# HISTORIC AND DESIGN REVIEW COMMISSION

March 20, 2024

**HDRC CASE NO:** 2024-109  
**ADDRESS:** 421 E COMMERCE ST  
**LEGAL DESCRIPTION:** NCB 148 BLK LOT 2 & 3  
**ZONING:** UZROW, H, RIO-3, D  
**CITY COUNCIL DIST.:** 1  
**DISTRICT:** Alamo Plaza Historic District  
**APPLICANT:** Ron Bechtol/Ron Bechtol, Architect  
**OWNER:** Wallace Rogers III/SCHULTZE & RILLING BUILDINGS  
**TYPE OF WORK:** Replacement of the exterior stair on the river side, installation of new umbrellas and patio elements, painting  
**APPLICATION RECEIVED:** March 01, 2024  
**60-DAY REVIEW:** April 30, 2024  
**CASE MANAGER:** Edward Hall

SITE PLAN BOUDROS EXPANSION

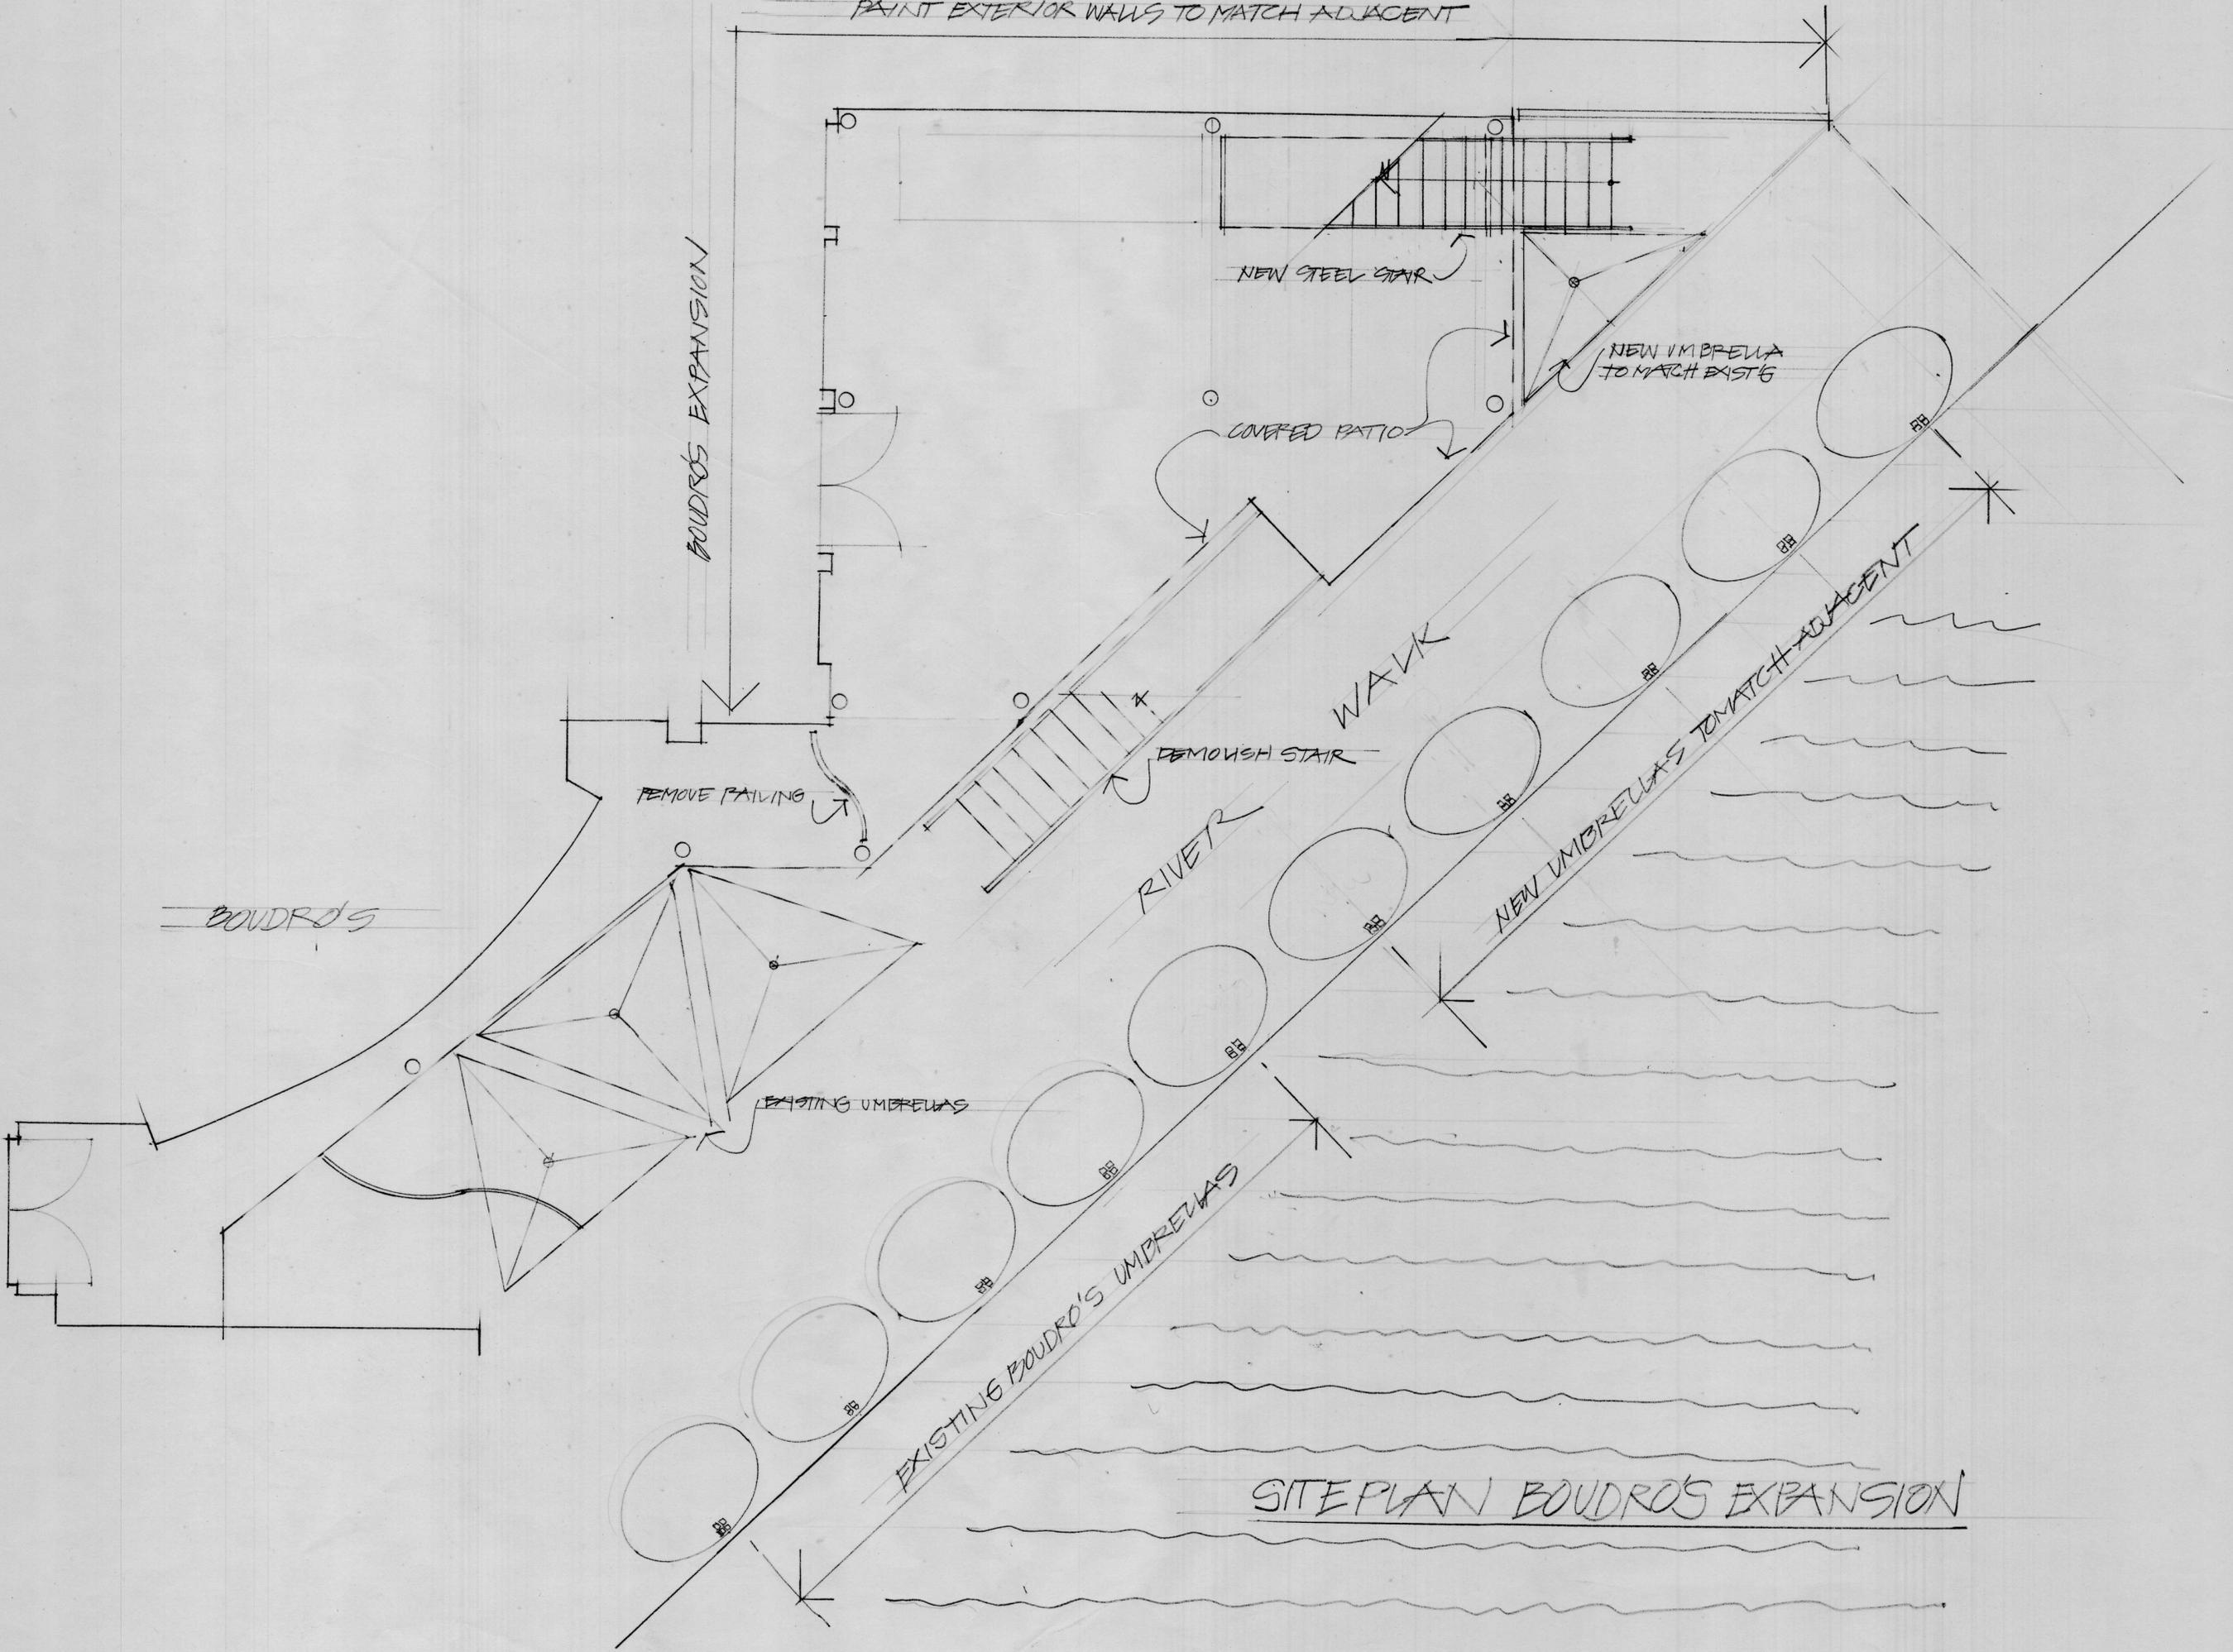
- c. PATIO FURNITURE & UMBRELLAS – The applicant has proposed to install patio furniture and umbrellas to match the design and profile of those currently installed at Boudro's to the north to extend to the immediate south of the pedestrian river bridge. Staff finds the proposed installation to be appropriate; however, patio furniture should not block the pedestrian pathway at the River Walk level. Additionally, per the UDC, umbrellas and patio furniture should not feature branding or signage.

- e. STEEL STAIR CONSTRUCTION – The applicant has proposed to remove an existing steel stair and construct a new steel stair in a location further within the site. This modification will create more site space and remove an existing barrier and obstruction (the stair) from being adjacent to the public right of way. The proposed stair will feature diamond plate risers and metal guardrails that match the existing stairs' guardrails. Staff finds the proposed stair to be appropriate and consistent with the UDC regarding its materials and design. Staff finds that the finish of the stair should be consistent with the finish of the existing stair.

1. Staff recommends approval of item #1, the installation of patio furniture and umbrellas based on finding c with the following stipulations:
  - i. That all patio furniture be installed in a manner that does not block the pedestrian right of way at the River Walk.
  - ii. That all patio furniture and umbrellas be free of signage and branding.
2. Staff recommends approval of item #2, painting, based on finding d with the stipulation that unpainted masonry elements (brick, cut stone, cast stone, and natural rock façade elements) remain unpainted.
3. Staff recommends approval of item #3, the construction of a new steel stair based on finding e with the stipulation that the finish of the stair and its elements be consistent with the finish of the existing stair.

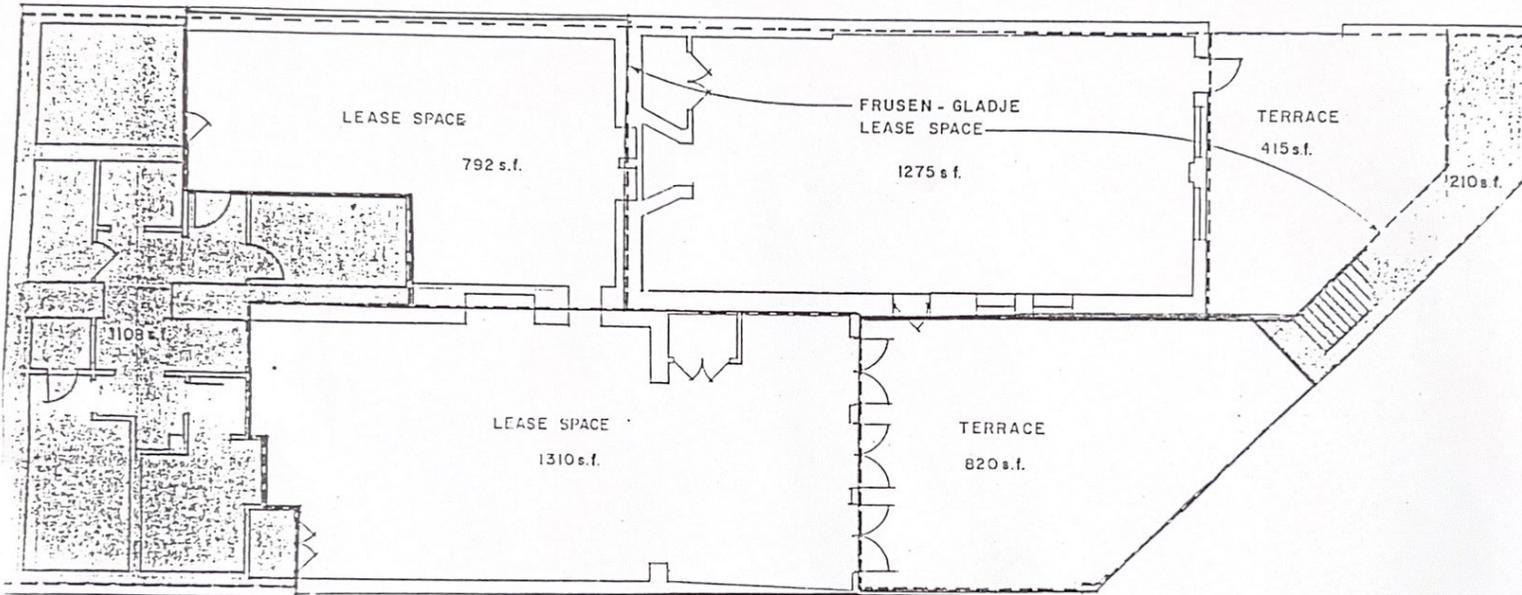
**EXISTING STAIR TO BE REMOVED. THE NEW STAIR WILL RESEMBLE THE EXISTING STAIR IN PROFILE AND APPEARANCE.**
